FOR PERCOLATION TESTING AND SITE EVALUATION

RE: 7514 Greenwood Drive (Greenwood Farms, Lot 21) Percolation Test Results,
A530325

PERCOLATION CERTIFICATION PLAN
 7514 GREENWOOD DRIVE
 Tax Map 40, Parcel 157, Lot 21

REMARKS micaceous subsoils, 15-16% slope #2 sidewall 3' to 10' minus 5' to 7'

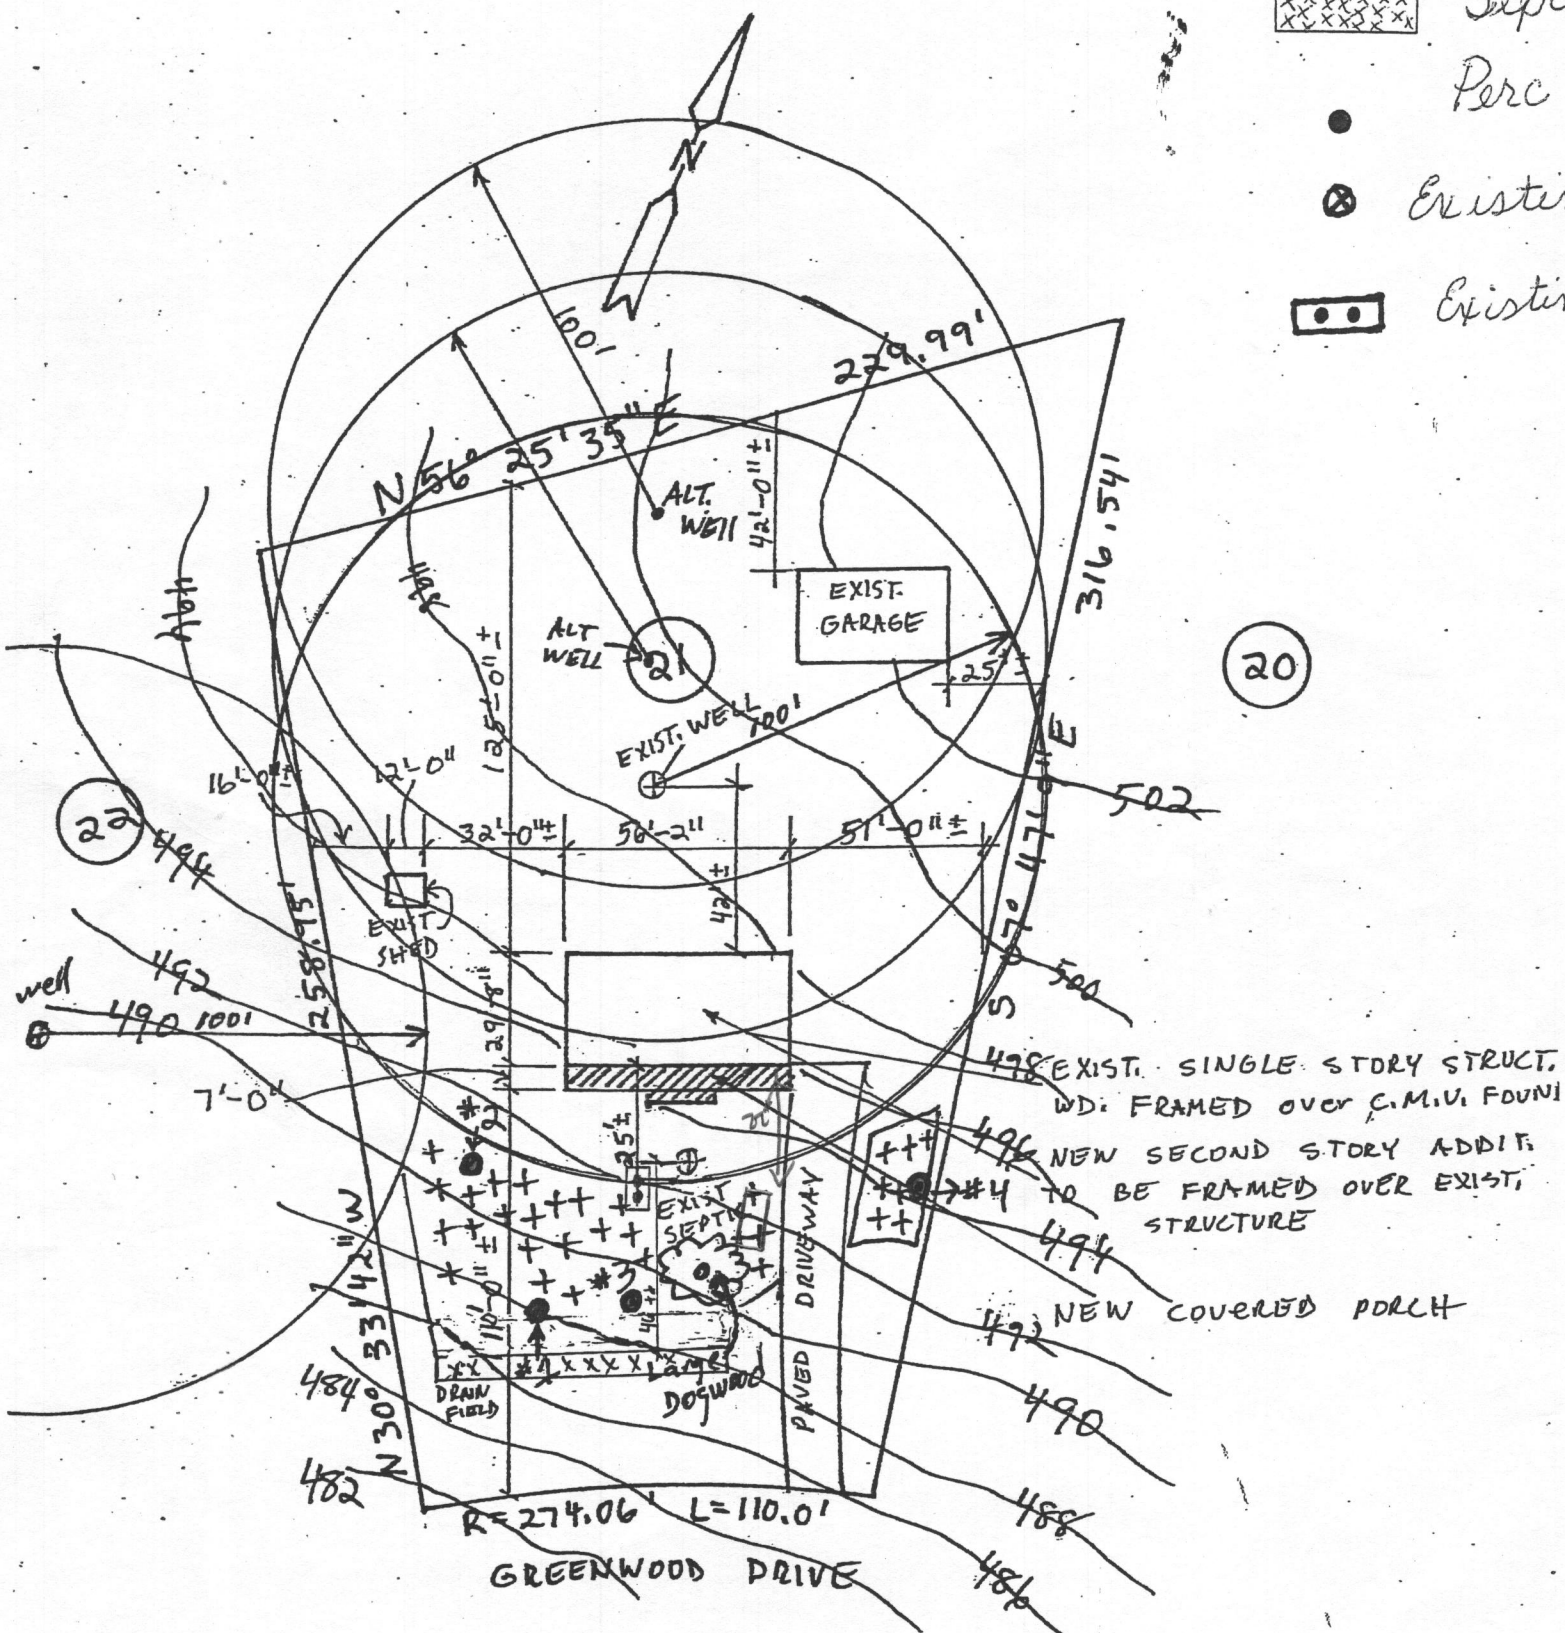
Three test holes were dug for profile description and standard percolation tests. Two test locations, #2 and #4, 'Pass' (with less than 30 minutes per inch of fall), and the other, #3, has a very slow rate of permeability (60 minutes per inch). Depth of percolation test was affected by the depth to groundwater at locations #2 and #3. The observed seasonal water table at location #2 is 14 feet, and at location #3 it is 9.5 feet. The restriction at #4 was densely consolidated materials at 11 feet.

Field data collected are shown on the Percolation Test Results Worksheets enclosed with this letter. Recommended Inlet and Trench Bottom depths, and Usable Sidewall are all based on observed soil properties and characteristics at respective test locations as well as the particular soils materials tested.
